Proposal for the 03 series of amendments of UN Regulation No. 137 (Frontal collision with focus on restraint systems)

Submitted by the expert from Japan

Model A

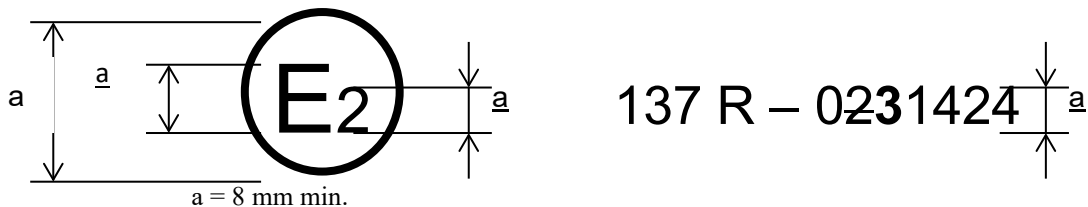
The above approval mark affixed to a vehicle shows that the vehicle type concerned has, with regard to the protection of the occupants in the event of a frontal collision, been approved in France (E 2) pursuant to Regulation No. 137 under approval number 0231424. The approval number indicates that the approval was granted in accordance with the requirements of Regulation No. 137 023 series of amendments.

Model B

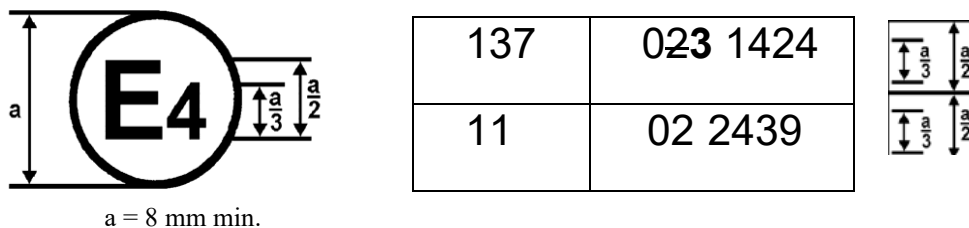
The above approval mark affixed to a vehicle shows that the vehicle type concerned has been approved in the Netherlands (E 4) pursuant to Regulations Nos. 137 and 11.¹ The first two digits of the approval numbers indicate that, at the dates when the respective approvals were granted, Regulation No. 137 incorporated the 023 series of amendments and Regulation No. 11 incorporated the 02 series of amendments.
